11-9270  
Atlanta Corporate Headquarters  
600 Peachtree Street, N.E.  
Atlanta, Georgia 30308  
(770) 447-1144  
(770) 447-1145  
www.nacintl.com

*Subject: Information Supplement in Response to the NRC Question on NAC-UMS®  
Universal Transport System Responses to RAI-1 on the Scale Model Side Drop  
Test (TAC No. L22452)*

### **UMS Scale Model Side Drop Test Results**

Figure 1. Overall Model Plot for the UMS Quarter Scale Model

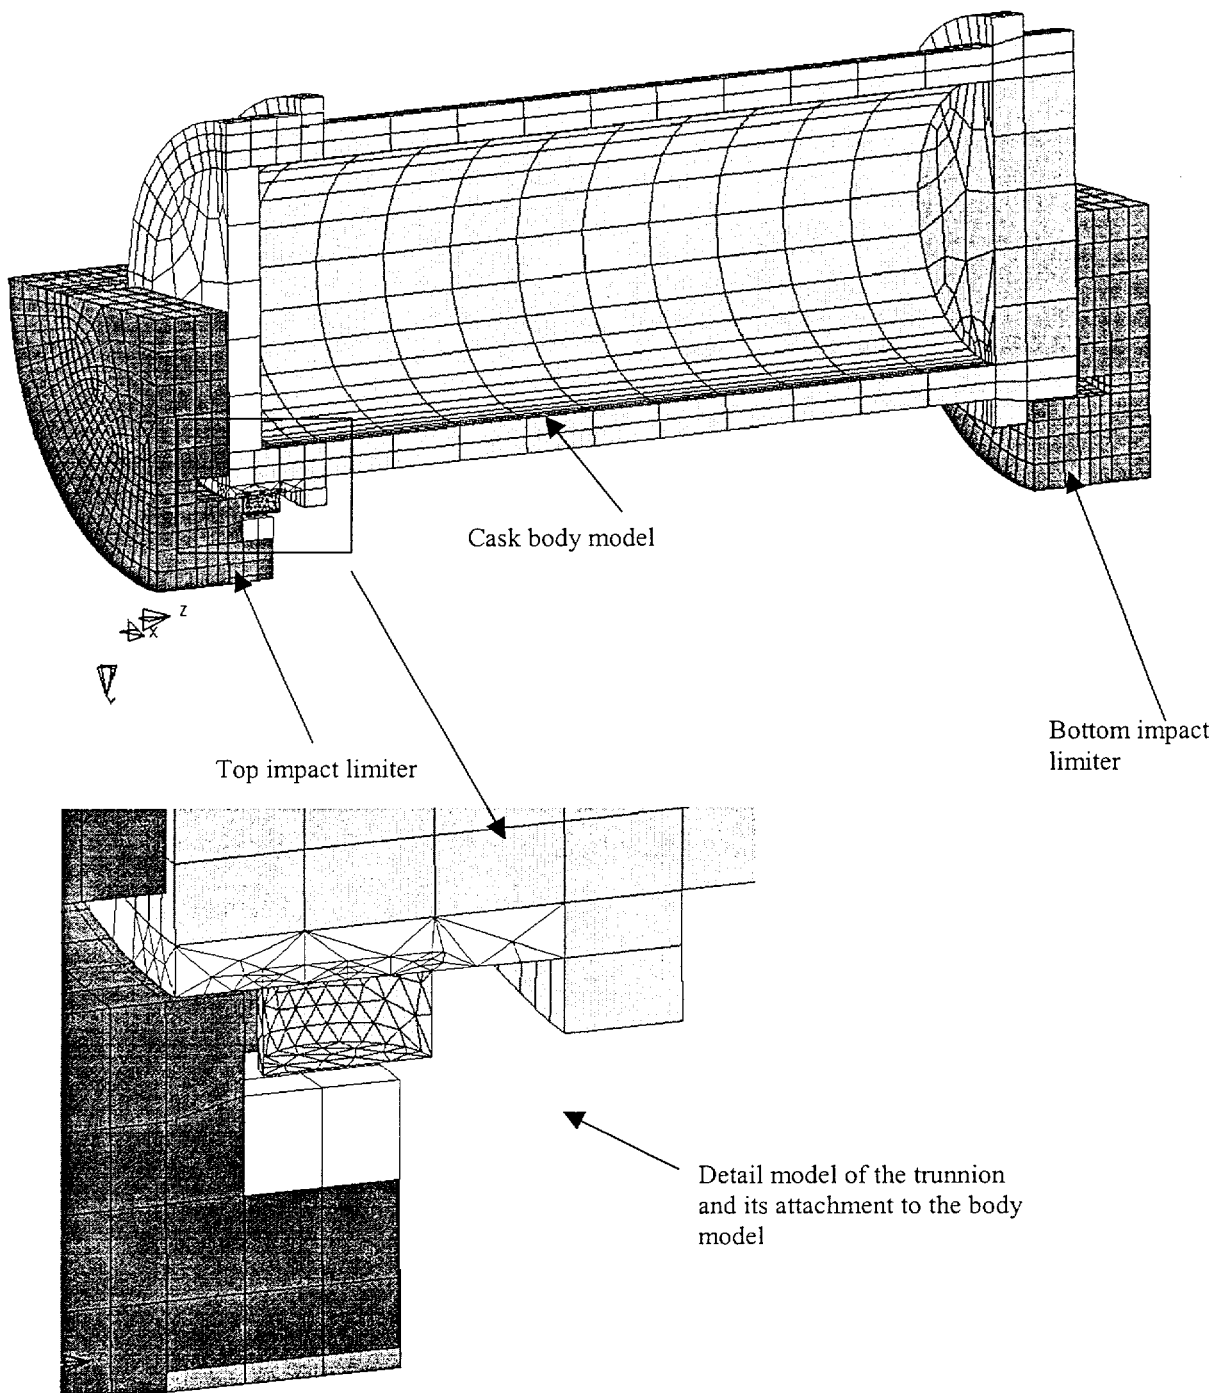
To examine the effect of removing the elastic response from the quarter scale model during the 30 foot side drop, an LS-DYNA model was constructed as shown in Figure 1. This model includes the top and bottom limiter as well as the body. Due to symmetry of the cask, only one half of the cask is modeled for this analytical evaluation. Symmetry boundary conditions were applied at the plane of symmetry. In this analysis, the body was made rigid by selecting the LS-DYNA rigid body option for the cask materials. Since the cask body was made rigid, further simplification of the model was permitted by distributing the concentrated weights of the scale model internals onto the body shell, while still maintaining the total weight and CG. The cask body used in this analysis also contains a trunnion, in which the model trunnion dimensions corresponds to the actual trunnion dimensions for the scaled model (Figure 1, detail). The trunnion in the model was represented by rigid shell elements. This modeling simplification did not affect the crushing of the redwood material and resultant cask response.

Figure 2. Model Plots for the Top Impact Limiter and Bottom Impact Limiters for the UMS Quarter Scale Model

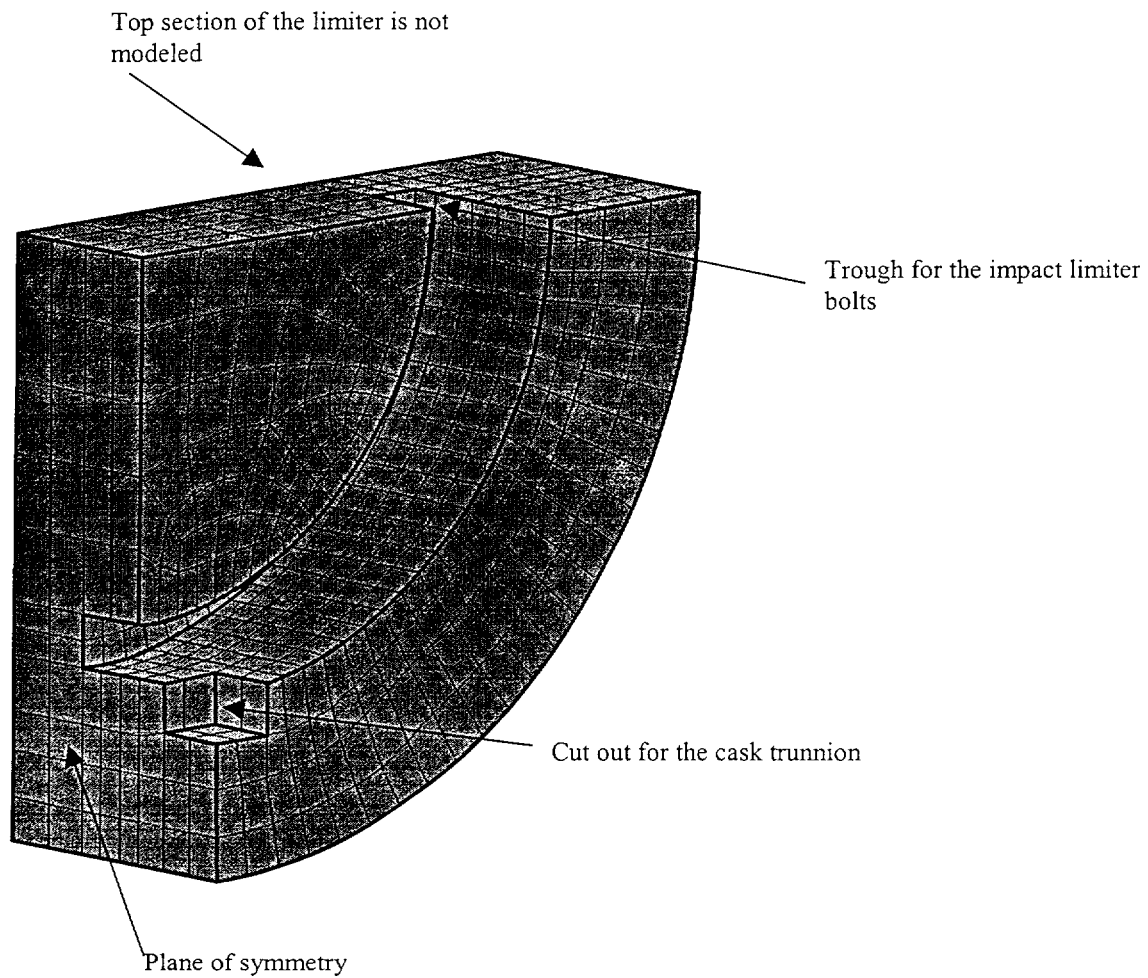
The significant feature of the actual limiter is the section of the impact limiter that experiences crush and decelerates the cask model. For this reason, without any degradation of the ability to model the impact limiter crushing, the detailed models of the limiters did not contain the upper half section of the limiter as shown in Figure 2. The dimensions used in the model correspond to those contained in the above referenced drawings for the quarter scale model. The top limiter (in Figure 2) shows that the cut out for the trunnion was modeled to accurately represent the redwood under the trunnion. The bottom impact limiter design and finite element model do not contain this type of cut out. Redwood parallel to grain properties are defined for the impact limiter material. The properties are taken at ambient temperature condition, representing actual test conditions. The impact plane is modeled as an unyielding surface. The analysis condition for this model included the following:

Figure 3. Acceleration Traces for the Rigid Body Model

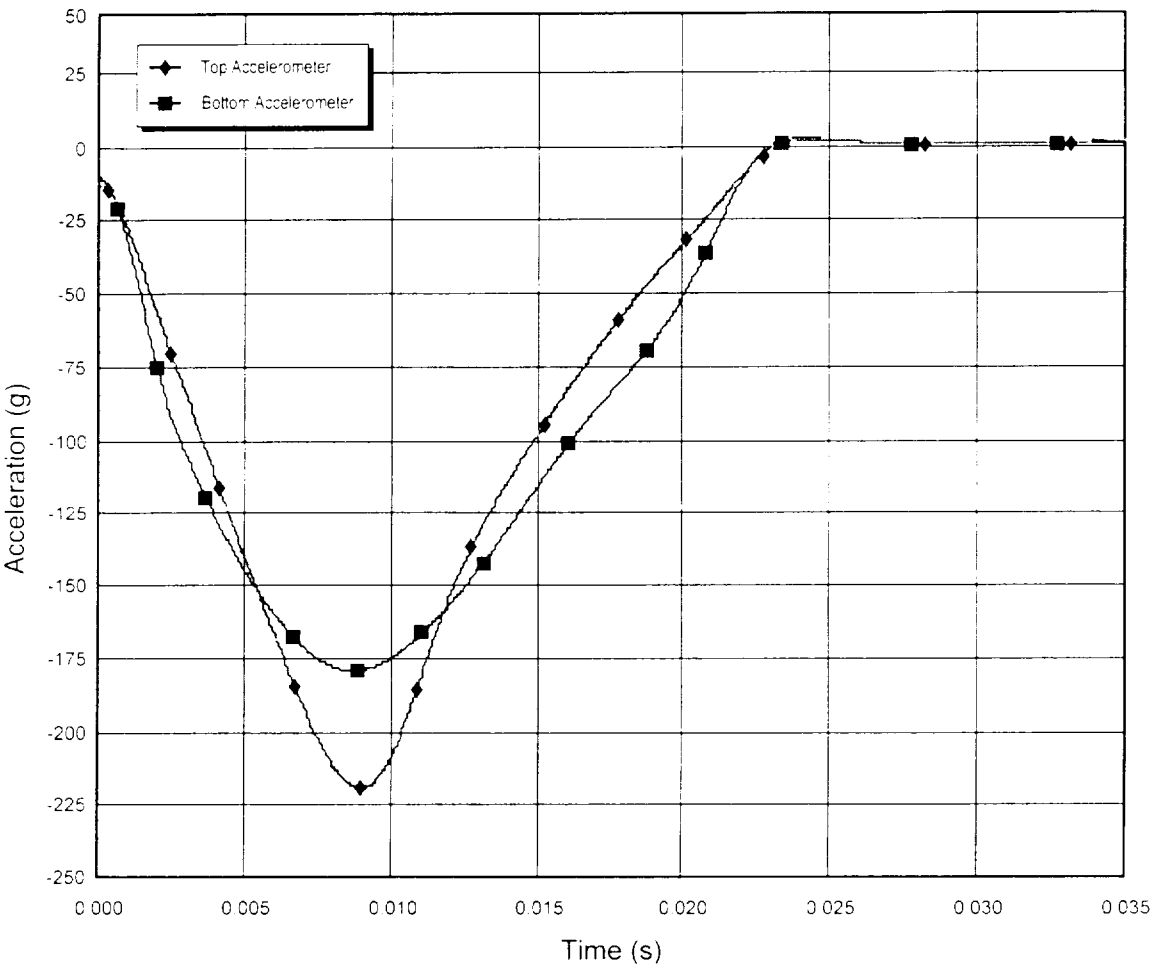
Two acceleration time histories were extracted at positions corresponding to the top and bottom accelerometers used in the drop tests. The acceleration traces are shown in Figure 3. These traces do not exhibit any positive peaks at the end of the drop test. The maximum accelerations were reported to be 219 g's and 180 g's for the top and bottom locations respectively.

These analytical results are representative of actual scale model drop test results presented in the UMS SAR.
